SECOND DRAFT BASIC ASSESSMENT

**THE PROPOSED STILFONTEIN TRUCK STOP AND FILLING STATION THAT IS SITUATED ON ERF 3675
STILFONTEIN EXTENSION 7 WITHIN THE CITY OF MATLOSANA LOCAL MUNICIPALITY WITHIN THE
NORTH WEST PROVINCE**

Ref nr. NWP/EIA/05/2022

1. COMMENTS RECEIVED FROM NWDEDECT ON THE DRAFT BASIC ASSESSMENT REPORT AND RESPONSE TO THE COMMENTS

Figure 22: Sewer drawings

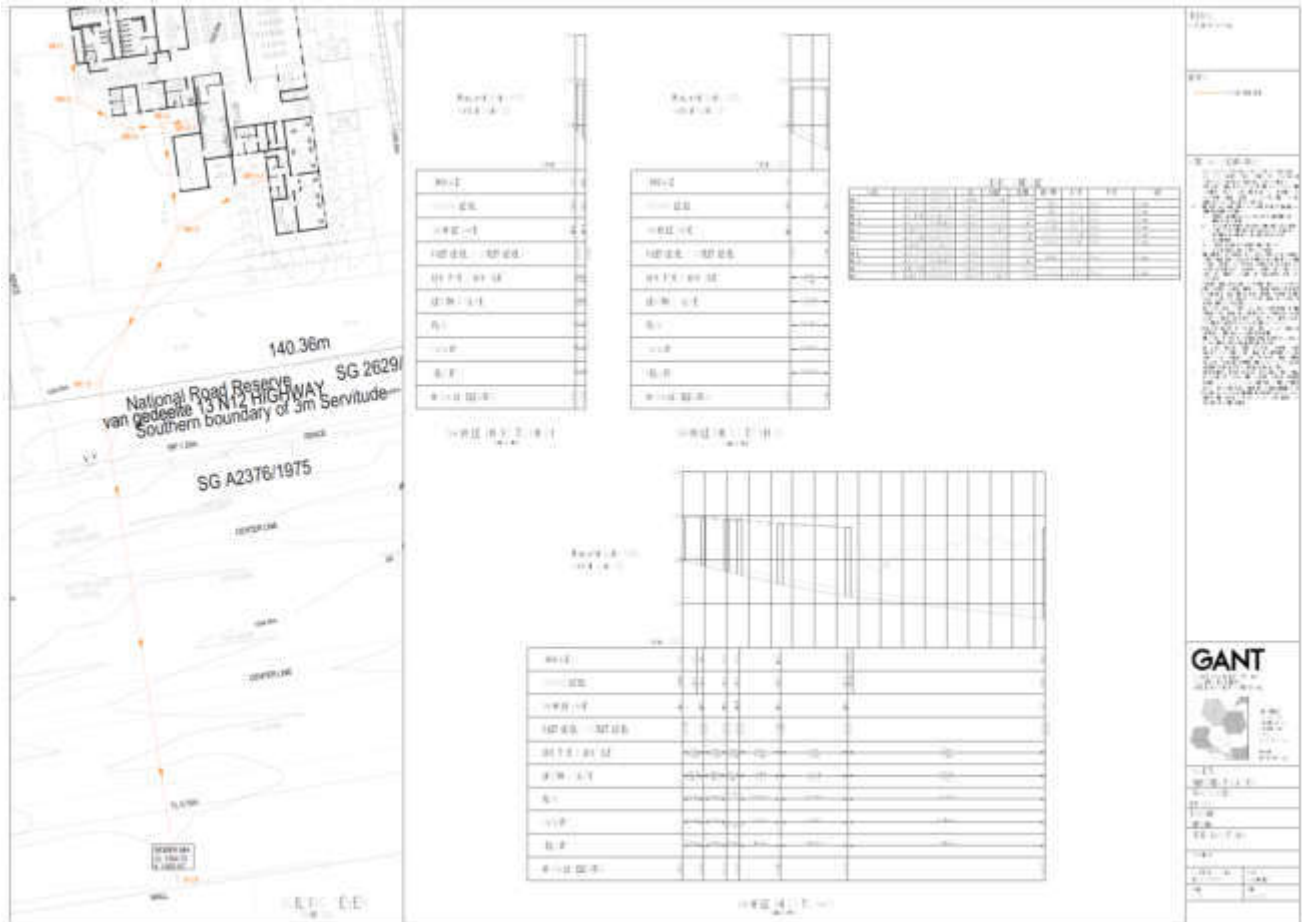
- (a) It was stated in the Draft Basic Assessment Report that water and sanitation/ sewer pipelines will be connected to the existing network. Confirmation that City of Matlosana has capacity to provide those services must be obtained and submitted.

There are no existing services on site. An option of septic tank on site or small package plant would be better. There is an existing network within Stilfontein area;

these will require pipe jacking across the N12 to connect to the existing manholes within the network. The developer must at own cost install a 160mm diameter sewer network for the new development in order to provide each erf with sewer connection.

Figure 24: Stormwater drawings

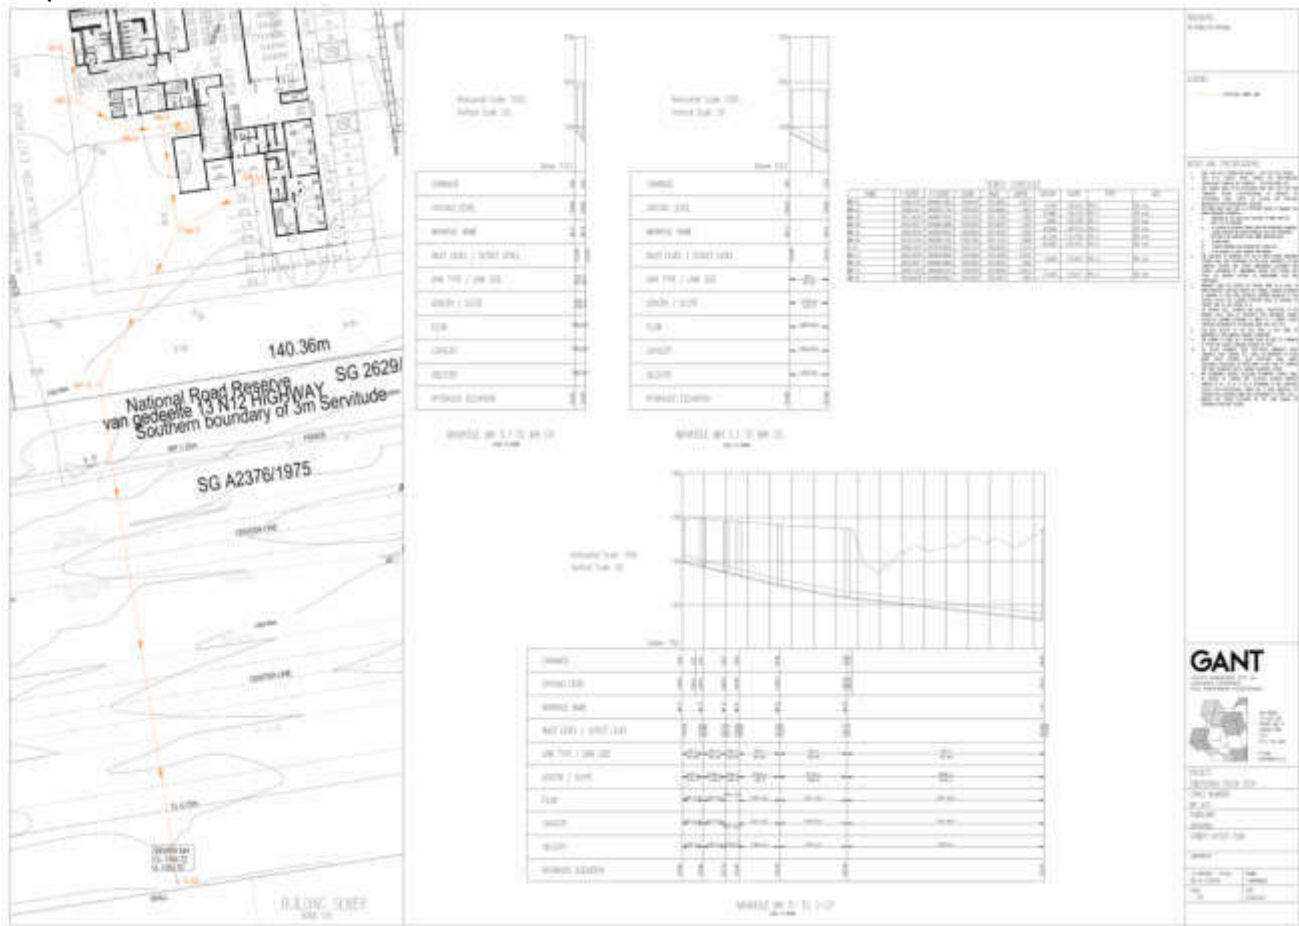
- (c) A detailed Stormwater Management Plan describing and illustrating the proposed stormwater and erosion control measures must be prepared and included in the report.

Existing services: There is no evidence of existing storm water systems on the site. There exists a borrow pit to the Southeast that will not be used for stormwater drainage. The site will be filled with G7 material (Natural Gravel), to ensure suitable drainage slopes. The Figure below shows the location of the pond and the direction of run off for the Truck Stop and Filling Station. The stormwater will be managed through surface runoff, channels, and stormwater pipes. The site will manage runoff to a Field Inlet where it will drain into a pipe. There is a connection point just east of Kowie Street, where the proposed pipeline will connect to.

Figure 44: Alternative 3 Layout

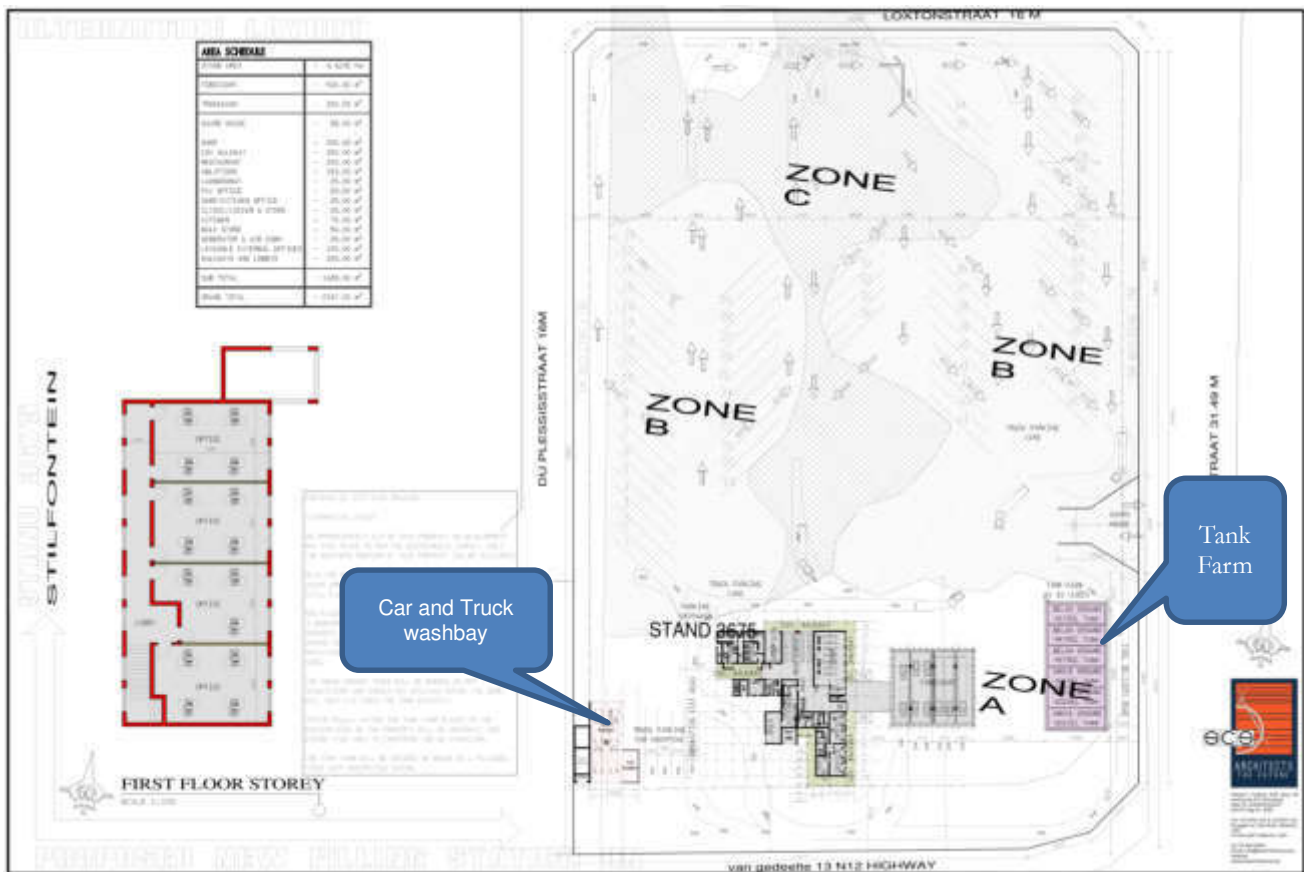
- (g) The preferred layout plan indicates that the fuel tanks be relocated further away from the impoundment.

Another layout has been considered for the site whereby the tanks are moved to the east of the site. Please refer to Alternative 3 Layout plan. The various layout alternatives are discussed in the report.
